## Service Bulletin

BKSB-1003  
Issue Date 09-29-00

**Issue:** GPH communication failure at high temperature (120–140F).

Figure 1

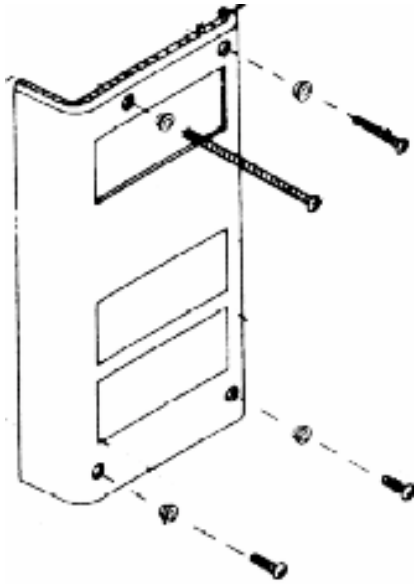
1. Turn off radio and remove battery.
2. Disassemble radio.
  - a) Remove 4 screws from rear cover of radio. (Fig. 1)
  - b) Pull front radio assembly straight out.
  - c) Gently slide white connector clip up and disconnect flex circuit from options board.
  - d) Remove five screws from options board and disconnect from keyboard. (Fig.2)
3. On the keyboard, remove R11. (Fig. 3)
4. Replace R11 with new resistor; P/N 4718-50317-198.
5. Reassemble Radio.
